AP1000 DESIGN CERTIFICATION REVIEW

Response to Request For Additional Information

RAI Number: 440.100

Figure 440.131-1: OSU Test SB18 ADS-4 IRWST Initiation Phase
Upper Plenum Collapsed Levels (Relative to Bottom of Lower Plenum)

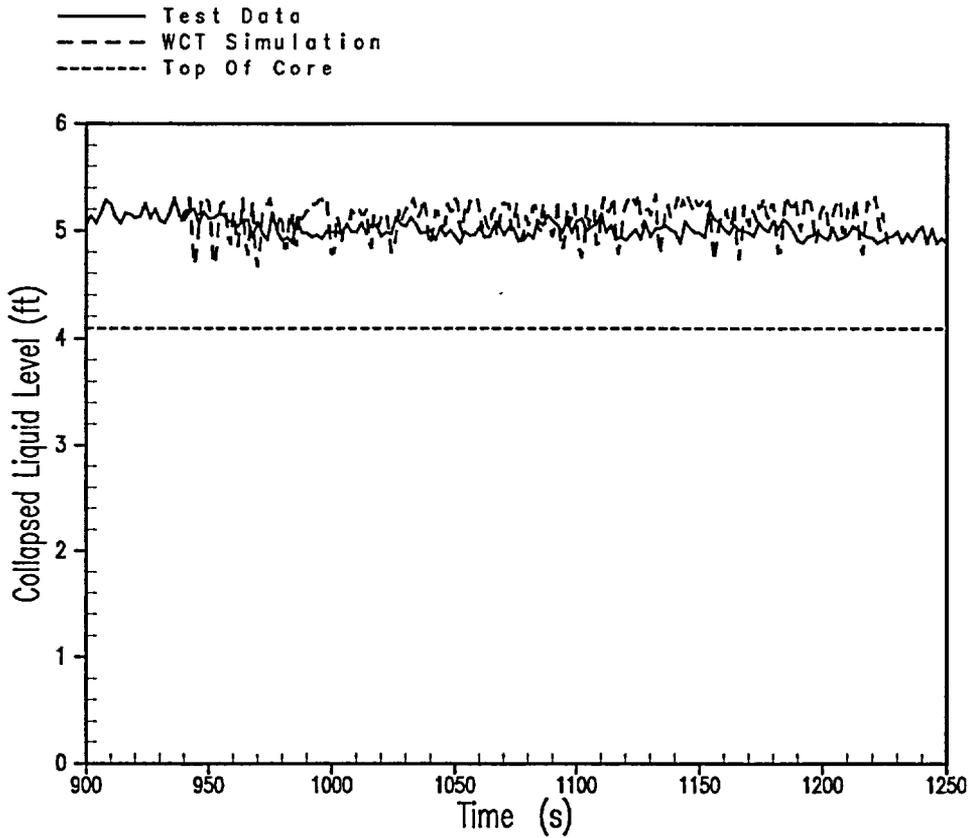
Figure 2-33 provides the WCOBRA/TRAC prediction of upper plenum collapsed liquid level for Oregon State University (OSU) test SB18. Comparisons with test data are not given. The applicable test data is given in Figure 5.1.2-12 of WCAP-14252, "AP600 Low-Pressure Integral Systems Test at Oregon State University Final Data Report." The values of upper plenum liquid level for the test are considerably lower than the WCOBRA/TRAC predictions. Discuss the cause of this apparent non-conservatism of WCOBRA/TRAC and its implications on SBLOCA analysis for AP1000.

Figure 5.1.2-4 of WCAP-14252 provides upper plenum void fractions for OSU test SB18. Please provide the corresponding predictions of upper plenum void fractions from WCOBRA/TRAC.

Figure 5.1.2-4 presents a simple translation of the Test SB18 measured collapsed liquid levels into steam percentages, as indicated by the title line "based on indicated level channels." This figure does not indicate two-phase mixture void fractions in the upper plenum, and it does not correspond to the WCOBRA/TRAC-predicted mixture void fractions in the upper plenum channels.

Since Figure 5.1.2-4 does not contain any additional information to that available from a liquid level comparison, it is more straightforward to compare levels directly. The attached figure is Figure 2-33 from WCAP-15833, but with the Test SB18 data for upper plenum collapsed level (relative to the bottom of the lower plenum) superimposed. The level predicted by WCOBRA/TRAC inside the core barrel shows reasonable agreement with the Test SB18 test data.

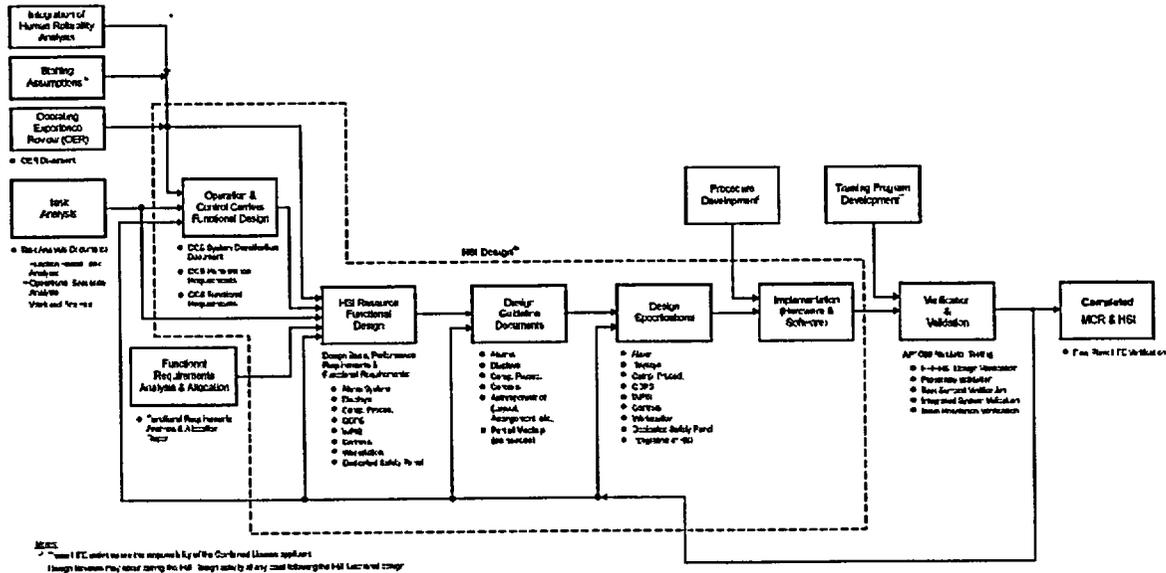
DCD Rev. 1, page 18.2-21, Figure 18.2-3. The figure should be modified if it is to remain in agreement with current NRC guidance, NUREG-0711, Rev. 1, May 2002. In addition, please provide the basis for all changes made to the HFE process from the process approved for the AP600 design.

An activity block corresponding to DCD Section 18.14, "Human Performance Monitoring", will be added to Figure 18.2-3 to satisfy NUREG-0711 Rev 1. See also responses to RAIs 620.008 and 620.018.

Figure 720.009-1
MAAP4 vs. NOTRUMP PRHR Heat Removal (AP1000)

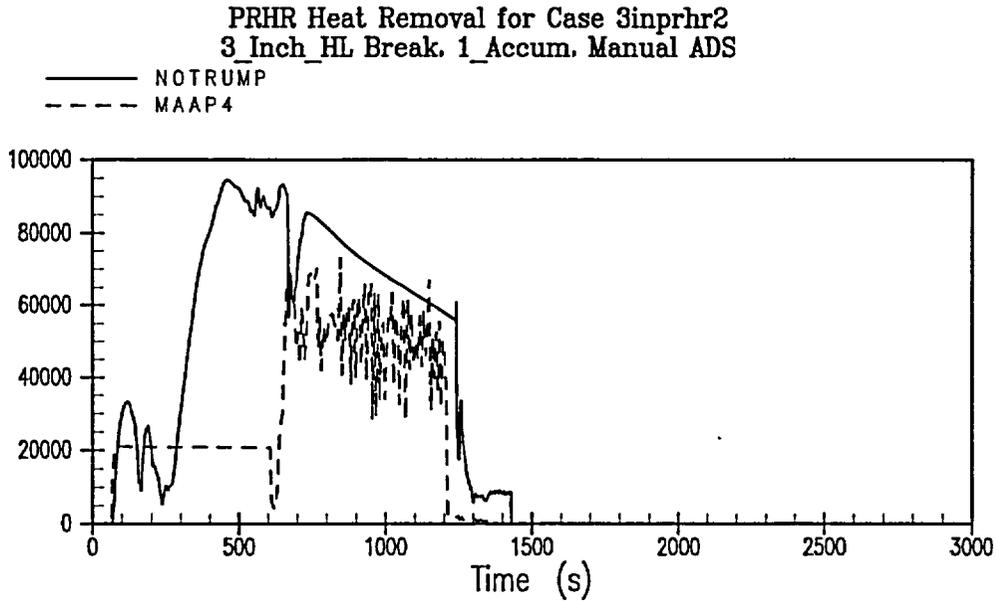
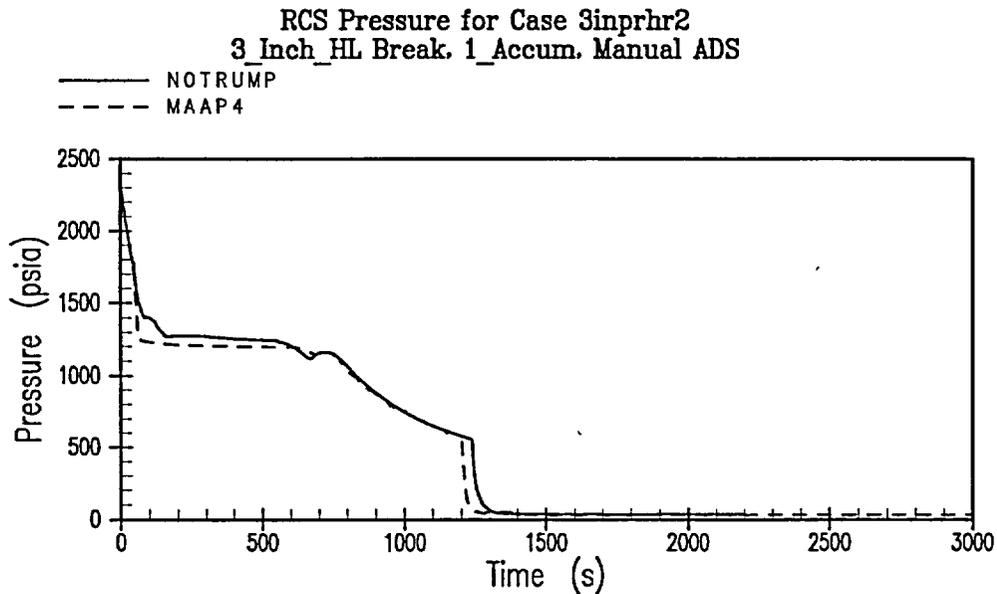
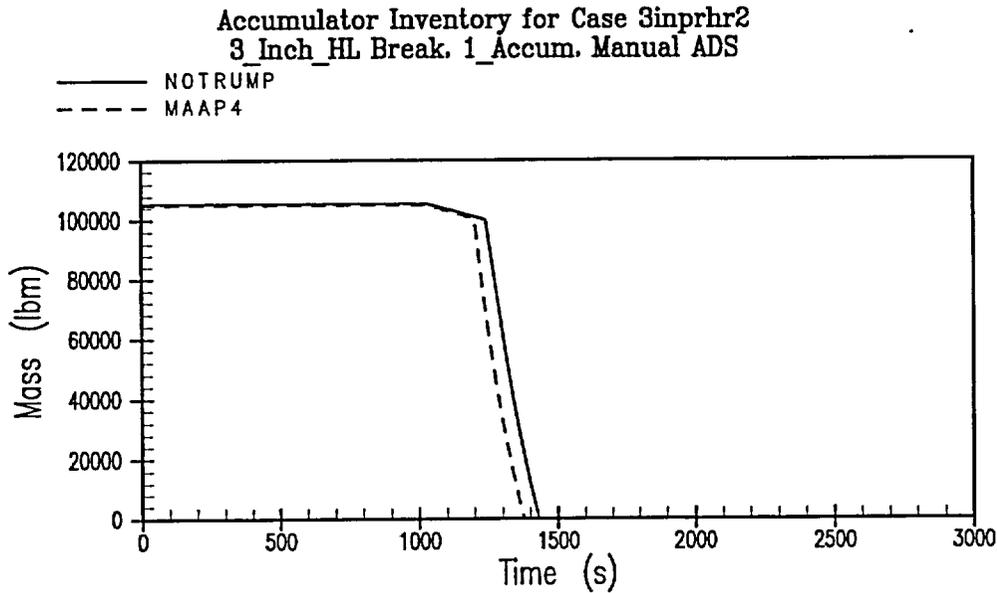
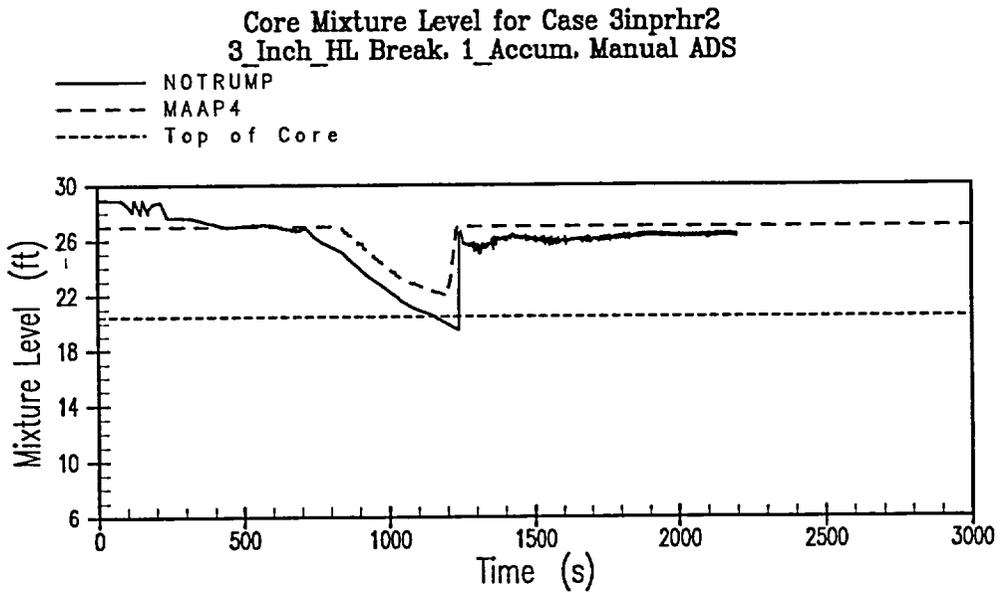
- B. Credit for the PRHR HX is stated to be required for some of these breaks, mainly between approximately 3 inches and 4 inches. In evaluating experimental data from the PRHR test facility, the nucleate boiling heat transfer correlation used in NOTRUMP was evaluated and found to produce heat fluxes that were too high in comparison to the data as the PRHR heat load increased. See Section 1.11 of WCAP-14807, "NOTRUMP Final Validation Report for AP600." Please provide analysis for the equipment operability assumptions listed in Section A.3.3.1 and Cases No. 1 and No. 2 in Section A5.1 showing that success will still be obtained if a PRHR HX correlation is used that matches experimental data.

- (B) The analysis reported in PRA section 3.3.1 was performed with MAAP4. For the medium LOCA success criteria analysis the MAAP4 PRHR HX performance was compared with the NOTRUMP PRHR HX performance for a 3" HL LOCA. Figure 720.009-1 shows that the

MAAP4 PRHR HX removes a similar, but smaller amount of heat from the RCS as a function of pressure. Figure 720.009-2, -3, -4 show the resulting RCS pressure, accumulator mass and core mixture level calculated by MAAP4 and NOTRUMP. These parameters are very similar between the two.
